In the Matter of)	
)	Docket Nos. 50-445 and
TEXAS UTILITIES ELECTRIC)	50-446
COMPANY, ET AL.)	
)	(Application for
(Comanche Peak Steam Electric)	Operating Licenses)
Station, Units 1 and 2))

AFFIDAVIT OF JOHN C. FINNERAN, JR. IN SUPPORT
OF APPLICANTS' REPLY TO CASE'S ANSWER TO
APPLICANTS' MOTION FOR SUMMARY DISPOSITION
REGARDING LOCAL DISPLACEMENTS AND STRESSES

SUBJECT 3-D OPEN END BOX BEAM

SHEET 11 OF 11

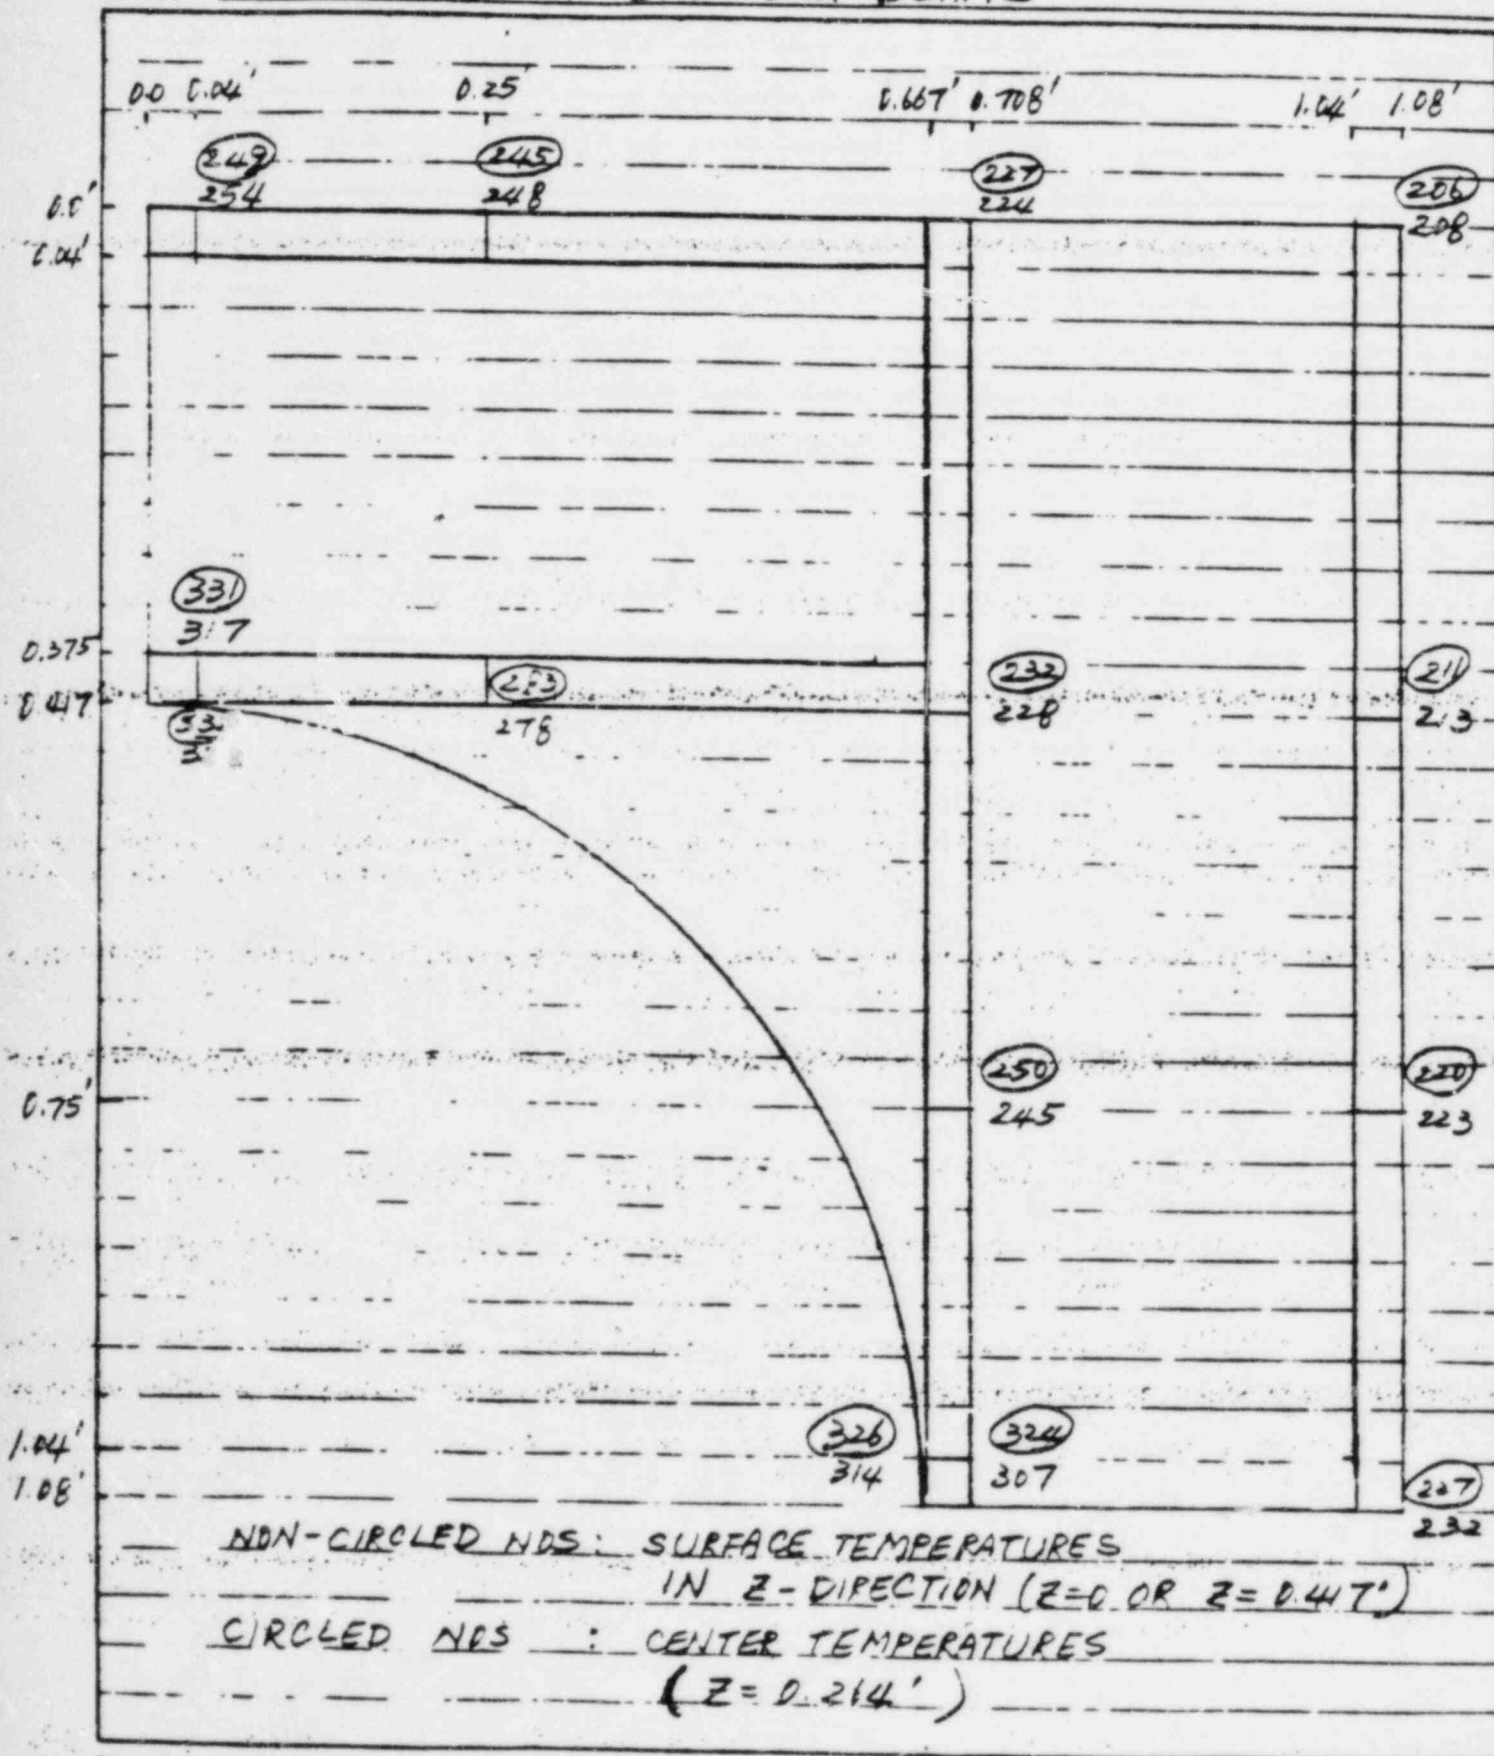
A. CASE contends that the temperature gradient in the tube steel will vary along the tube from that existing through the tube at the point of contact of the frame and the pipe (Affidavit at 4). However, CASE does not point to any particular effect it believes this varying temperature gradient will have on Applicants' analysis. Consequently, it is not possible to respond directly to CASE's argument. It should be noted, nonetheless, that Applicants' finite

difference analysis mentioned above demonstrated that the temperature gradients along the tube are, in fact (as originally assumed) nearly linear across the frame and along the length of the tube away from the point of contact between the frame and the pipe (Attachment A; sh. 11 of 11). Thus, although the gradients do vary, Applicants' assumption of linearity for taking an average temperature of the tube was reasonable and, in fact, conservative given the conclusion from the finite element analysis that the lowest temperature in the frame (206°F) is actually higher than the average temperature (203°F) originally assumed. Thus, the expansion of the frame will actually be greater than initially estimated.
